PARK CITY MUNICIPAL CORPORATION
ADMINISTRATIVE ACTION MEETING MINUTES
PLANNING DEPARTMENT
June 27, 2024
<https://us02web.zoom.us/j/88167820277>

2960 Arabian Drive – Administrative Permit – PL-24-04182 – The Applicant Proposes Construction of a Detached Accessory Apartment in the Single-Family Zoning District.

Neighbor's Comments to Application: PL-24-04182 at 2960 Arabian Drive

Administrative Application for Accessory Apartment on June 27, 2024

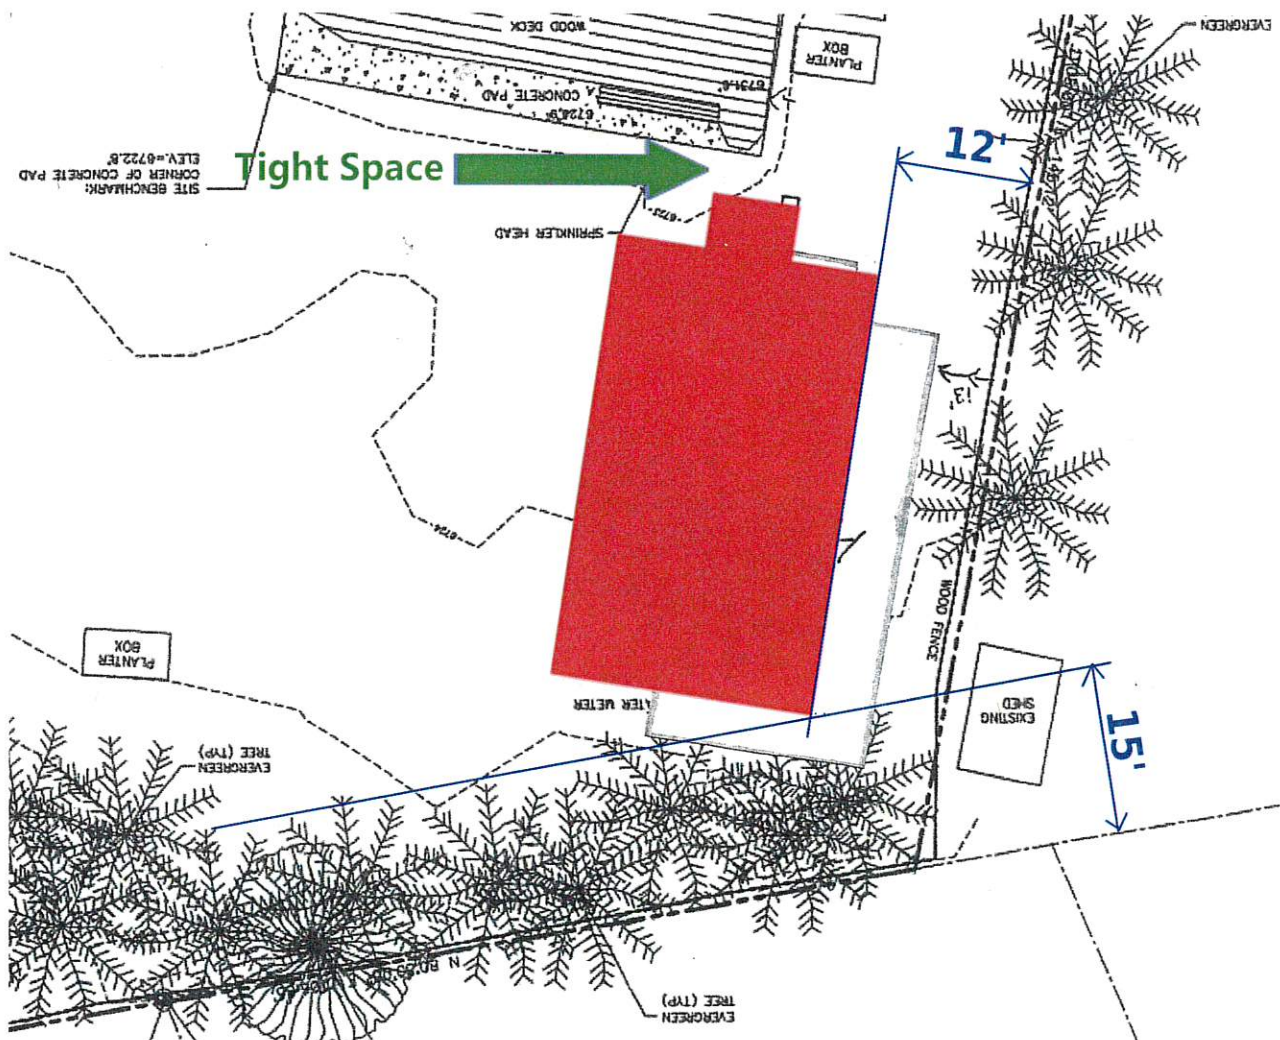
1. On the floor plan, the total area is 1,008 square feet, exceeding the 1,000 square feet limit for such a dwelling.
2. On the survey, the footprint is not to scale and appears to encroach on both setbacks (less than 15 feet from the rear property line and less than the 12 feet from the side property line). The drawing should be corrected and re-submitted to the adjacent property owners for further comments if necessary.

I have attempted to reset it to scale, reducing the entrance area by 8 square feet (now 8 feet by 5 feet) and observed the required setbacks:

What is visible is that the front of the dwelling is brought very close to the existing deck attached to the house. Also, the rear of the dwelling is a bit too close to the existing pine trees (fire safety).

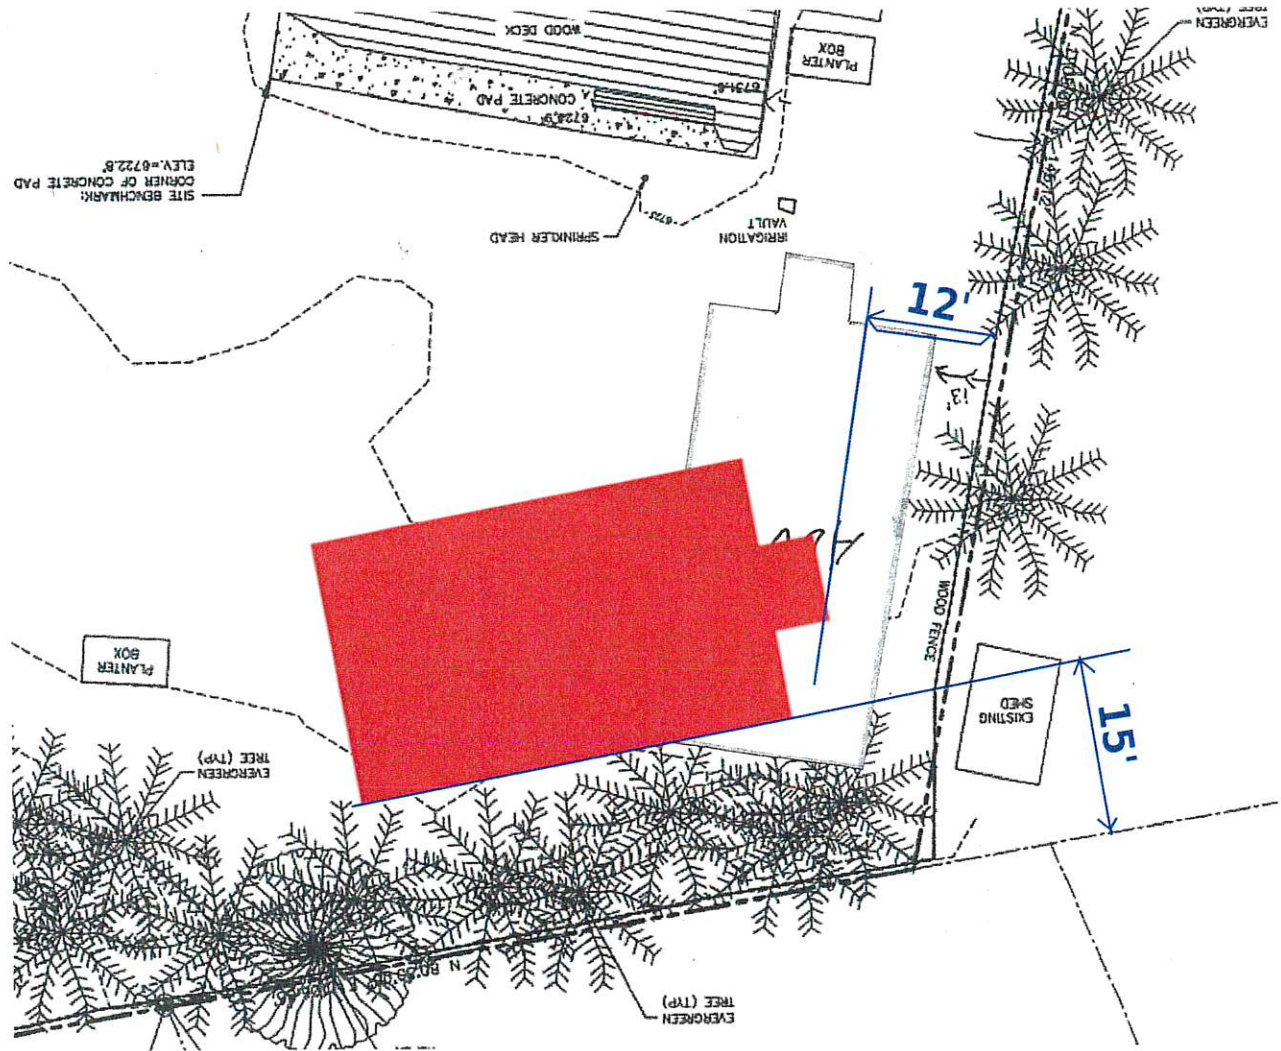
3. An alternative would be to place the Accessory Dwelling so the main facade faces south and fully benefits from the sun. If placed on the 15' rear setback, the rear of the proposed dwelling would also butt against the clump of pine trees planted in the alignment of the rear line of setback, which wouldn't be desirable from a fire danger standpoint.

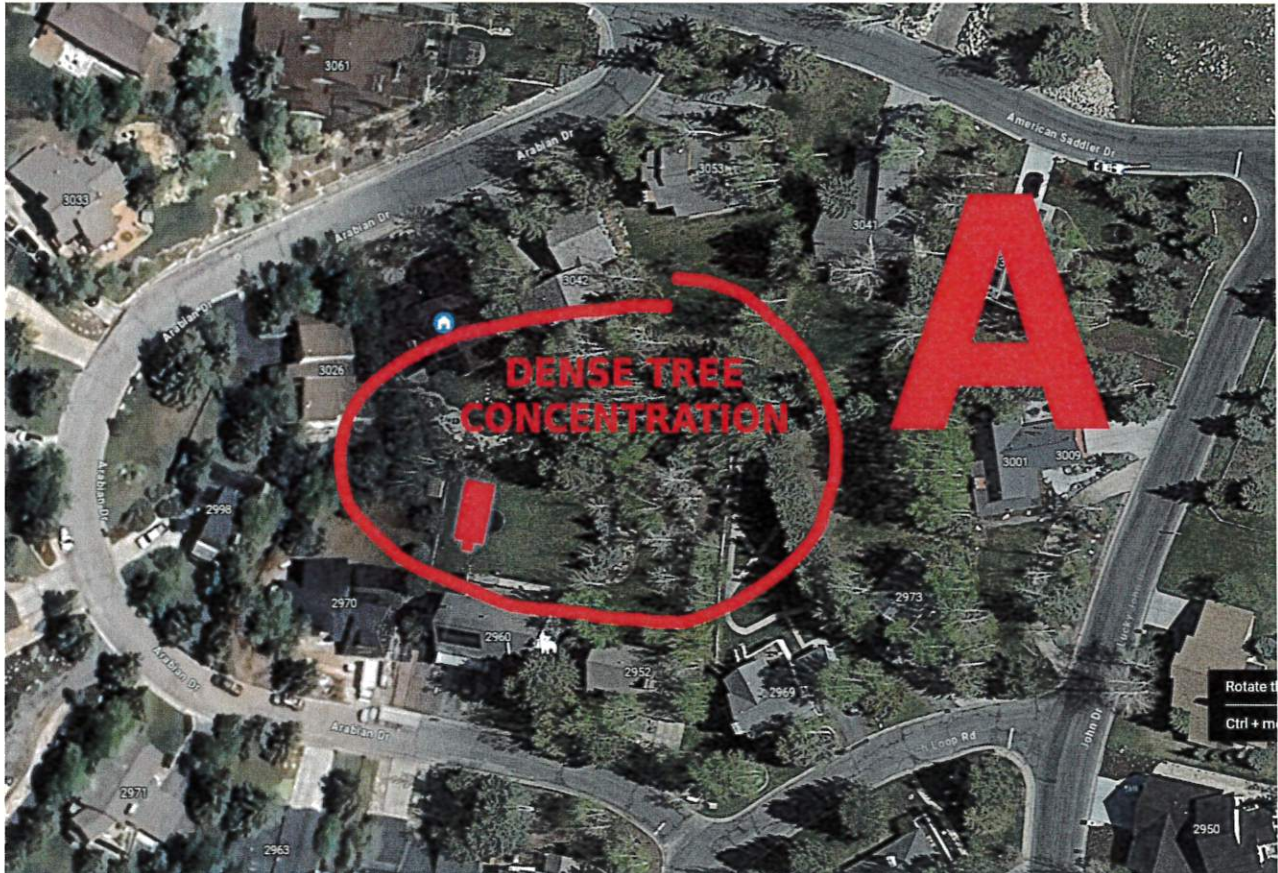
4. This brings us to the potential issue of fire danger in our our particular area.

The small residential block comprised between Arabian Drive, American Saddler, Lucky John Drive and Holiday Ranch Loop Road, but most particularly around our property and the dwelling location, is filled with a tight density of trees, including many conifers (with a few that are standing dead). Some are dangerously hugging dried out, wood shingles on one house, and we are not reassured by that.

Since there is little we can do to convince our other homeowners to clear some of their trees off their properties (pine trees in particular) we do not wish to see more conifers hugging buildings in the vicinity, and logic would suggest that they should be cut.
